# Rezoning Transportation Analysis

Petition Number: 2017-097

Date	Description
07-20-17	First Review

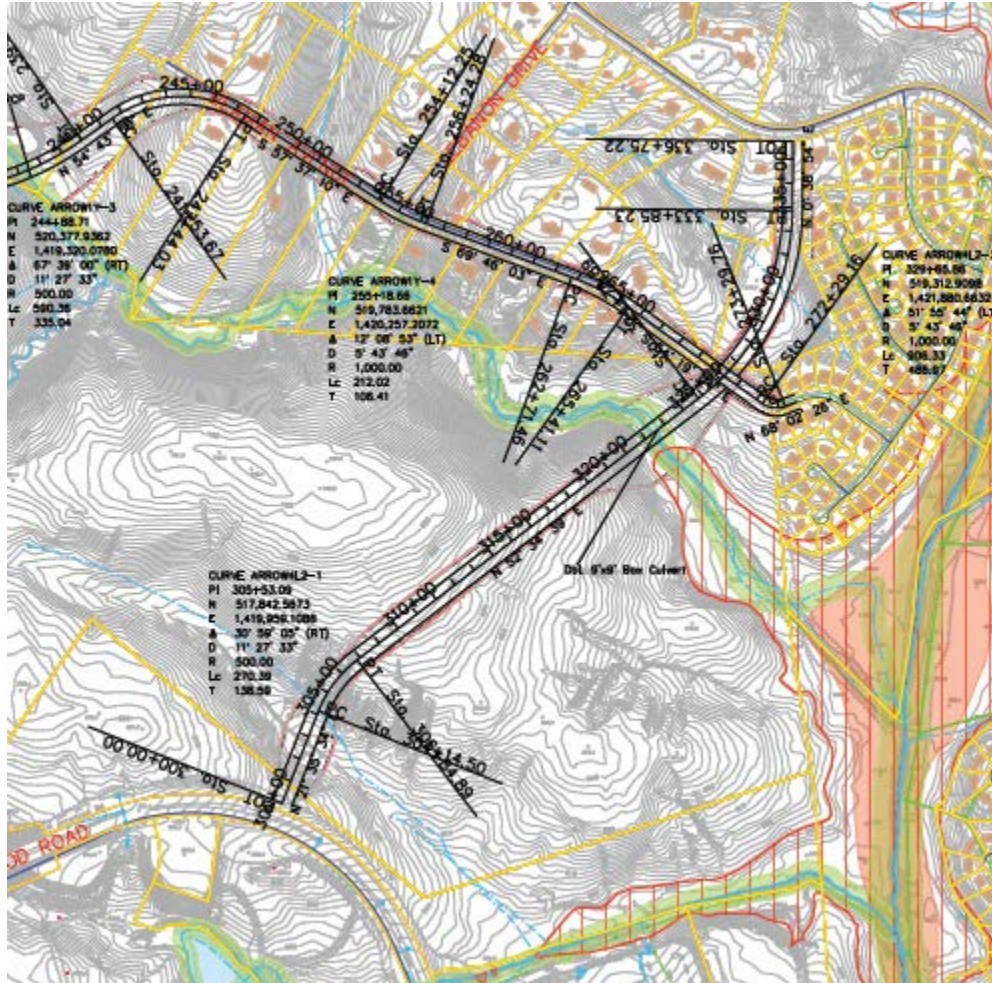
- Traffic Study** A Traffic Impact Study/Transportation Technical Memorandum is needed for the complete review of this petition. TIS scope has been approved. CDOT has not yet received TIS for review. Coordination with NCDOT is intended. Further comments are anticipated once the study is submitted and reviewed.
- The petitioner should revise the site plan and conditional note(s) to show Shopton Rd Extension from Pinecrest Dr/Sirona Dr to Beam Rd as identified in the Airport Area Master Plan. 2-lane divided with appropriate bike and ped facilities.

- The petitioner should revise the site plan to show the proposed south most entrance aligning with the proposed Arrowood Rd-Shopton Rd Connector. 2-lane divided with appropriate bike and ped facilities.

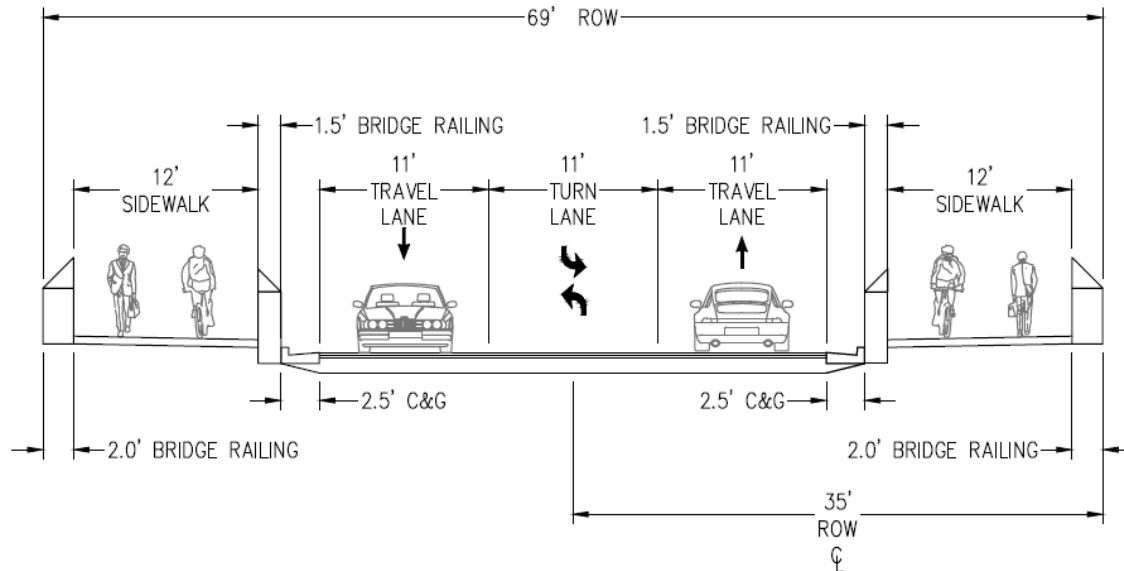
- The petitioner should revise the site plan to show 2.5 foot curb and gutter, 8 foot planting strip and 6 foot sidewalk on existing Shopton Rd. The back of curb location is 41 feet from centerline of Shopton Rd.
- The petitioner should revise the site plan to show dedication of right of way, fee simple, 57 feet from centerline of existing Shopton Rd to accommodate the envisioned future cross section.
- The Coffey Creek bridge on Shopton Rd is to be replaced as part of a CNIP project. Street improvements should tie in to anticipated cross section below. Contact Felix Obregon at 704-432-5729 to discuss project specifics and coordination, as needed.
